**2006 No. 399**

**The Traffic Signs (Amendment) Regulations  
(Northern Ireland) 2006**

*Made* - - - - - *2nd October 2006*

1016.1

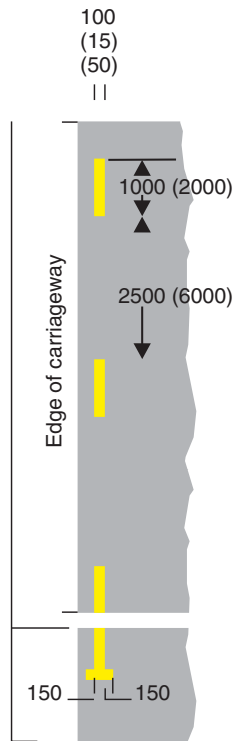
- (a) after diagram 1014 there shall be inserted the diagram specified in Part I of the Schedule and the words specified in and under it;
- (b) for the words “Alternative types of parking bay reserved for doctors-(a) at the edge of the carriageway or situated wholly on either the carriageway or the footway; or (b) in the centre of the carriageway or partly on the carriageway and partly on the footway” below diagram 1028.4 there shall be substituted the wording specified in Part II of the Schedule;

Longitudinal line to be laid near the edge of the carriageway to indicate to vehicular traffic that waiting by vehicles on a side of a length of road is prohibited or restricted

Item	
1	Regulations: None
2	Diagrams: 639.1A, 641, 660, 660.3, 660.5, 660.6, 660.7, 661, 661A, 661.1, 662, 663, 663.1, 664
3	Permitted variants: None
4	Illumination requirements: Schedule 17, item 10
